DRB Application No.: 05DRB-00205 (SBP)	Project # 1003929
Project Name: ALAMEDA BUSINESS PARK	Dhone Not 255 5040
Agent: Sanders Associates Architects	Phone No.: 255-5040
Your request for (SDP for SUB) (SDP for BP). F approved on SZ (SDE) by the DRB with del OUTSTANDING SIGNATURES COMMENTS TO	
UTILITIES:	
CITY ENGINEER / AMAFCA:	
D PARKS / CIP:	
PLANNING (Last to sign): Column	pfanguage on 2/11/05
-Tax printout from the County Ass Include 3 copies of the approve County Treasurer's signature m with the County Clerk	reasurer. o the County Clerk). RECORDED DATE: sessor. d site plan along with the originals. sust be obtained prior to the recording of the plat are must be obtained prior to Planning Department's d.

11. Project # 1003929
05DRB-00205 Minor-SiteDev Plan
BldPermit

CITY OF ALBUQUERQUE PLANNING DEPARTMENT February 16, 2004 DRB Comments

RE: Lot 42, Alameda Business Park/SPBP

C:\Drawings Active\Drawings 2004\p429 Baker Construction office warehouse\Construction document\C-2 landscape.dwg, 2/4/2005 4:56:47 PM, HP designed 130

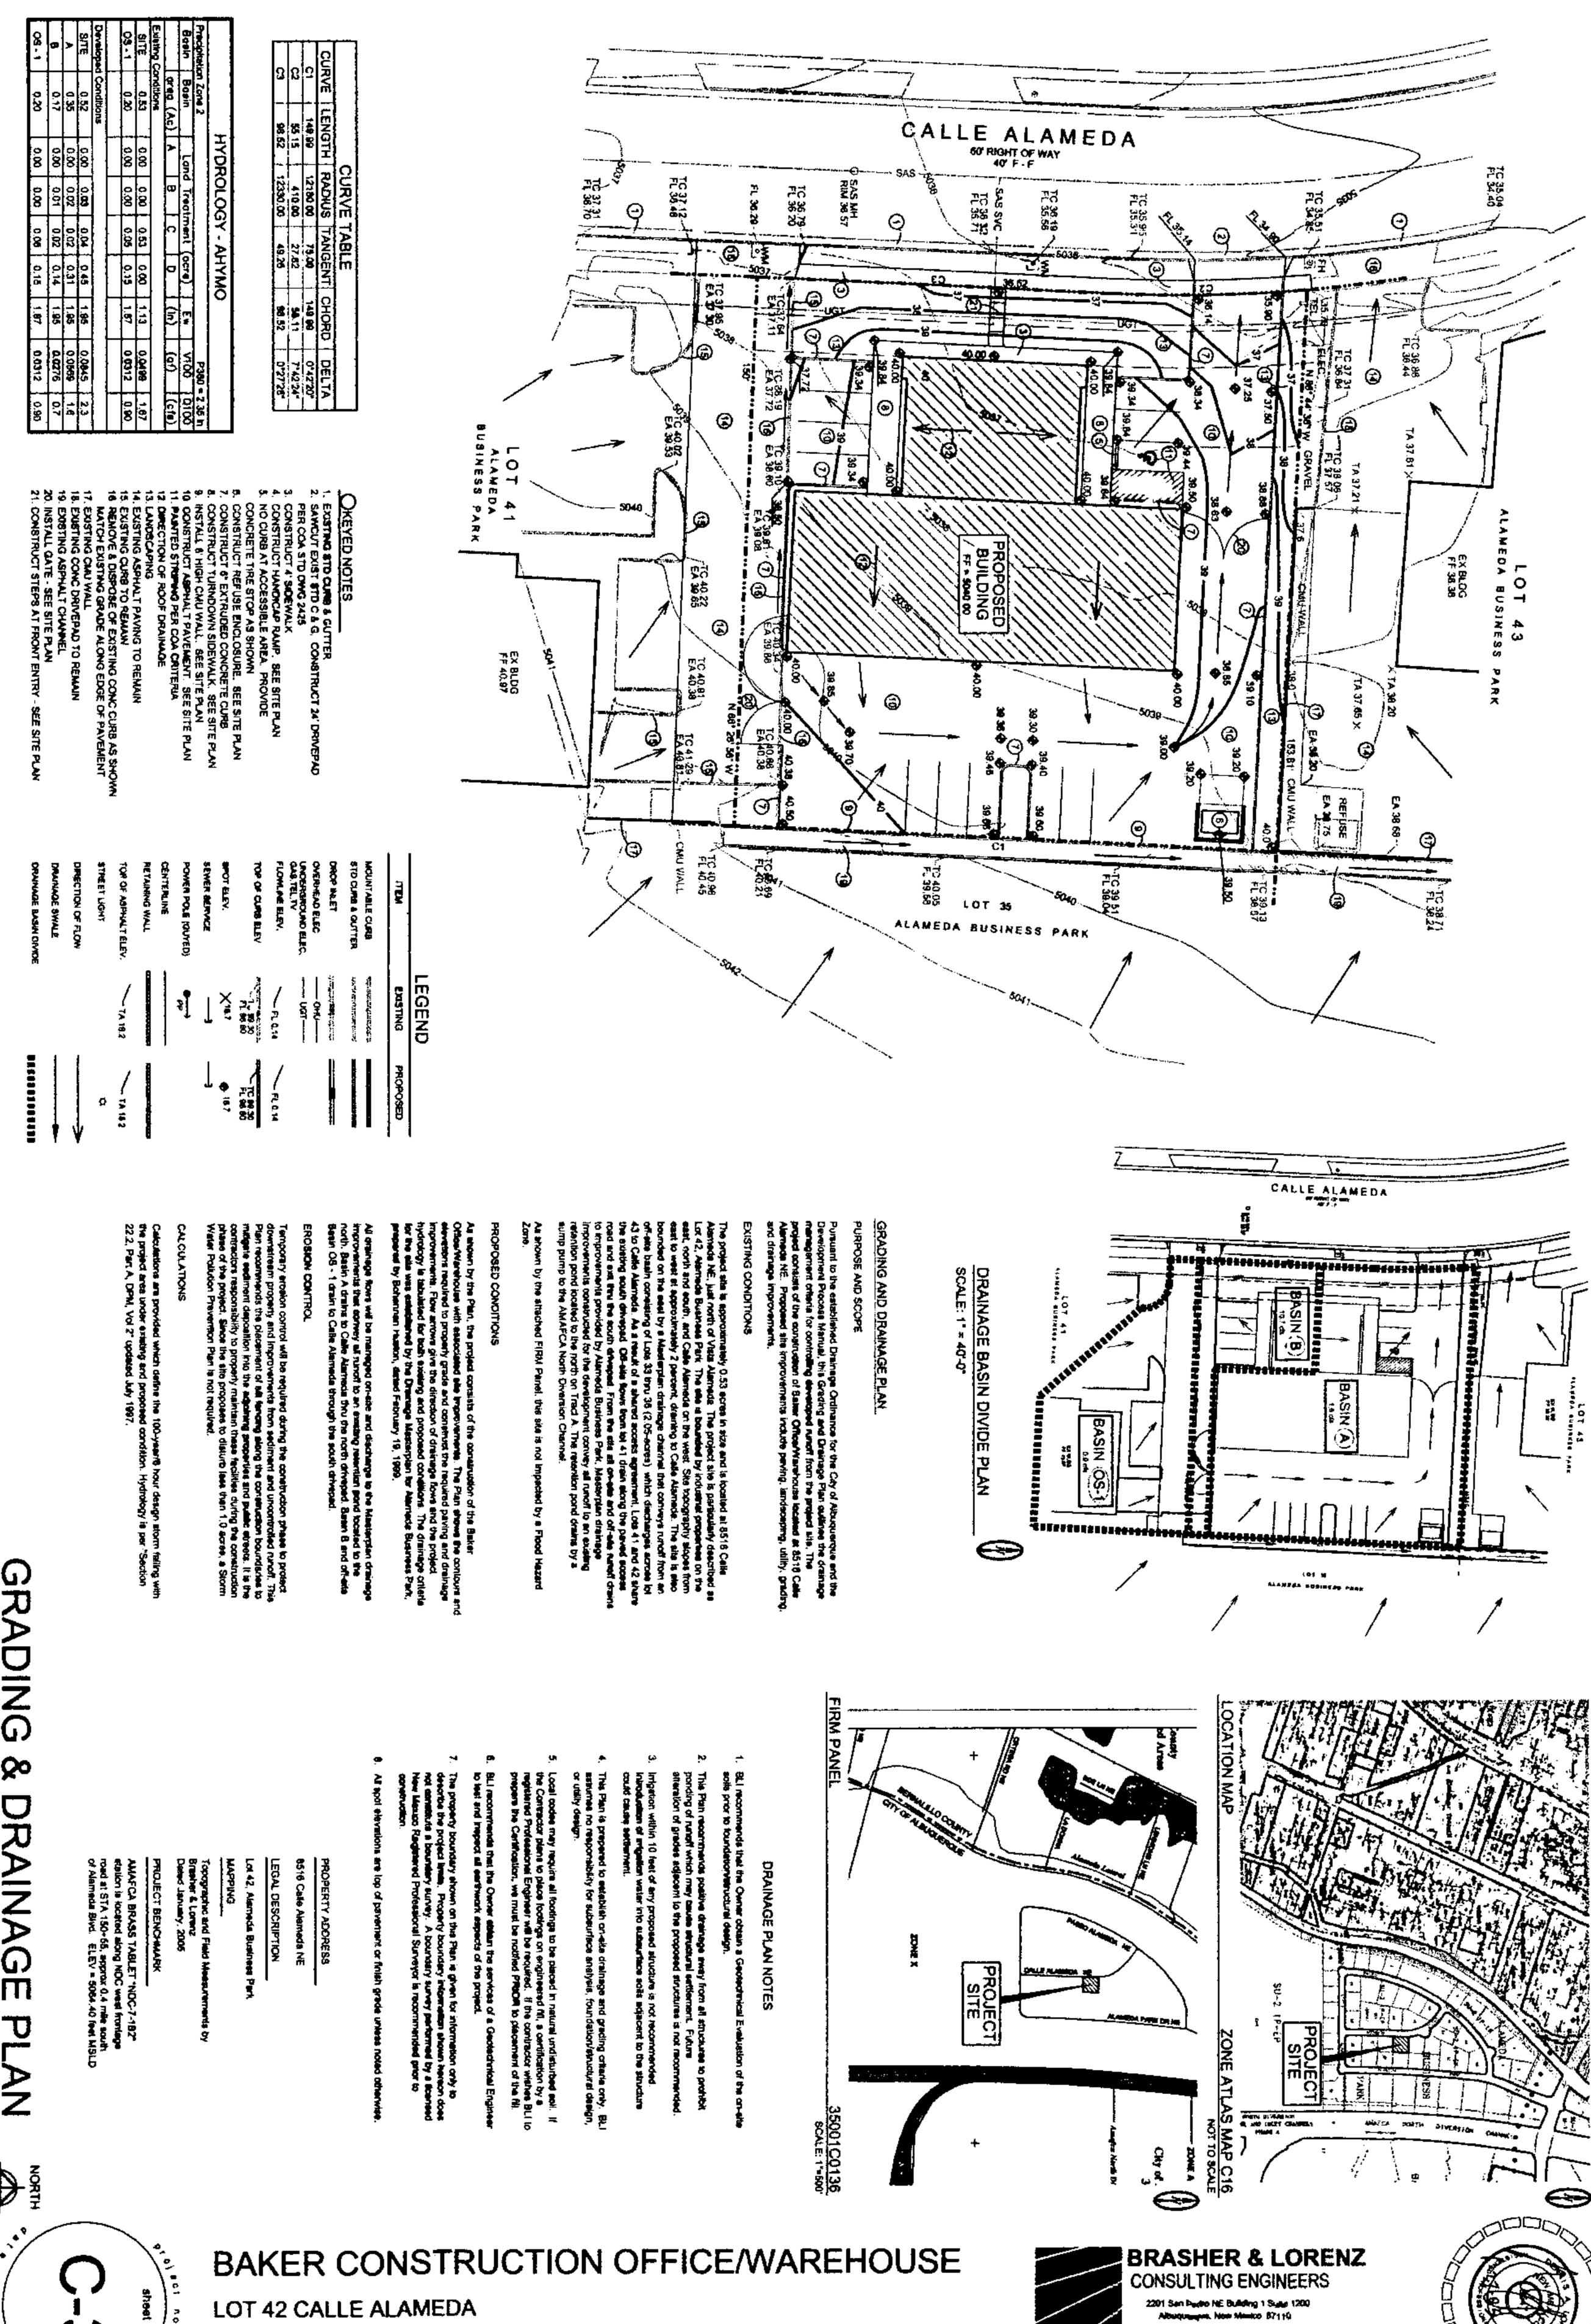
- 6. The dumpster enclosure elevation should be placed on one of the sheets in the SPBP.
- 7. On Sheet C-2, please place the title by the "Landscape Plan" by the C-2.

Comments on the Landscape Plan in the SPBP: (high pure with 125 Sector Plan)

The required 6' rear yard landscape buffer is missing.

Both this plan & the Alameda Business Park Master Plan require all parking spaces to be no more than 50' form-a tree.
 The SPBP states 100'.

The gravel in the Landscape Plan should have color. The Alameda Business Park Master Plan requires Santa Ana Tan gravel. Santa Fe Brown is an acceptable substitute.

- 1. The signature block has been revised to match the City standard.
- 2. The proposed use of Office and Warehouse has been added on the building footprint.
- 3. There is no building signage proposed per the property owner's direction.
- 4. There is no loading dock the overhead doors on the east side of the building are drive in doors.
- 5. Lighting is mounted on the building and there are to be no pole mounted lights. All lighting will be shielded per the note on sheet C-1.
- 6. The dumpster enclosure elevation has been placed on sheet C-1.
- 7. "Landscaping Plan" has been added next to C-2.

1. It is our understanding that the required North I25 rear yard landscape buffer will not be required because the rear of the site is walled and thus screened from view. Jack Basye has indicated that they rear landscaping buffer may be omitted in a note that is attached.

The note on the landscaping plan has been corrected concerning the requirement that no parking space be farther that 50' from a tree. The landscaping plan reflects no parking space is further than 50' from a tree.

2. A note has been added to the landscaping plan that the gravel shall be Santa Ana Tan.
